Report for Resolution

Report to Planning Applications Committee
Date 11 November 2010
Report of Head of Planning Services
Subject 10/01422/F 216 Newmarket Road Norwich NR4 7LA

Item
5 (1)

drawing title:
Proposed Site Layout

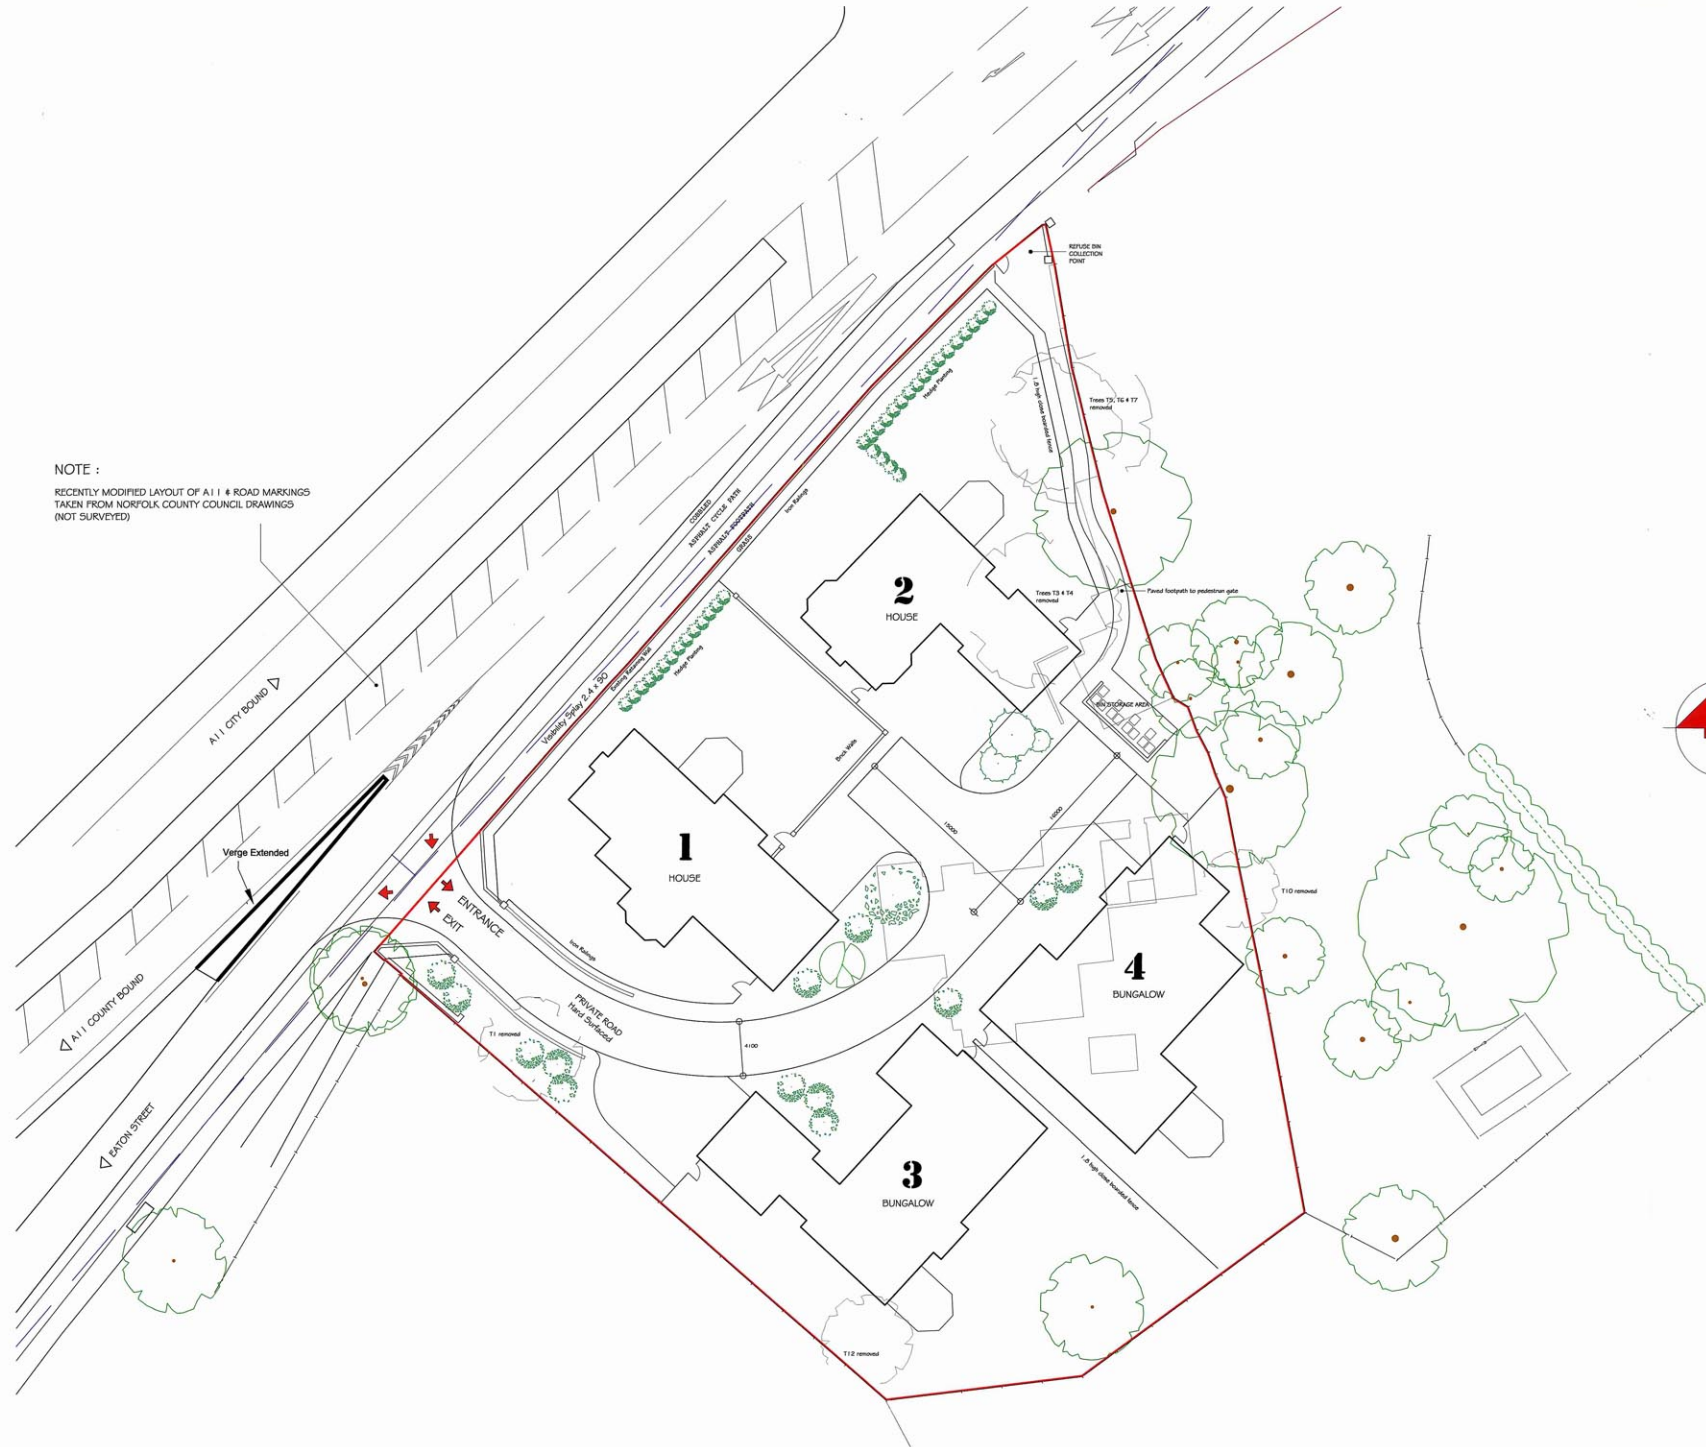
- An Arboricultural Method Statement (AMS) is required for the demolition of the existing building where it conflicts with the Root Protection Area (RPA) of T9.
- Bungalow 4 is proposed too close to RPA of T9; root pruning may be a possibility but will require an AMS which should include foundation detail that shows a DPC grade liner to keep wet concrete leachate out of the root soil profile.
- Paved footpath within RPA of T8 should be reconfigured to be outside the RPA or should be of a no-dig construction to the Council's approval and constructed under arboricultural supervision.
- The coal bunker to be removed will require inclusion in the AMS.
- Tree protection measures should be conditioned.

33. The scheme as originally submitted indicated that plot 3 would be located close to the boundary of the site and include details such as a steeply pitched gable roof. The garden depths of the neighbouring properties on Chestnut Hill are not excessively large and concern was expressed that the proposed development would be overbearing for the residents of those existing dwellings, due to the proximity between the properties and the difference in land levels concerned.

34. Consequently, amendments have been made to the scheme to re-site the dwelling on plot 3 some three metres further from the boundary and to amend the design details of the scheme to propose a hipped roof with a lower ridge height. These changes are considered to have successfully addressed the concerns raised previously and the scheme, as amended, is not considered likely to be unacceptably overbearing for the existing adjoining residents.

A	Plot 4 garage reduced in size, bungalows 3 & 4 moved north - eastward	grc	Oct 10
No	Revision/issue details	By	Date
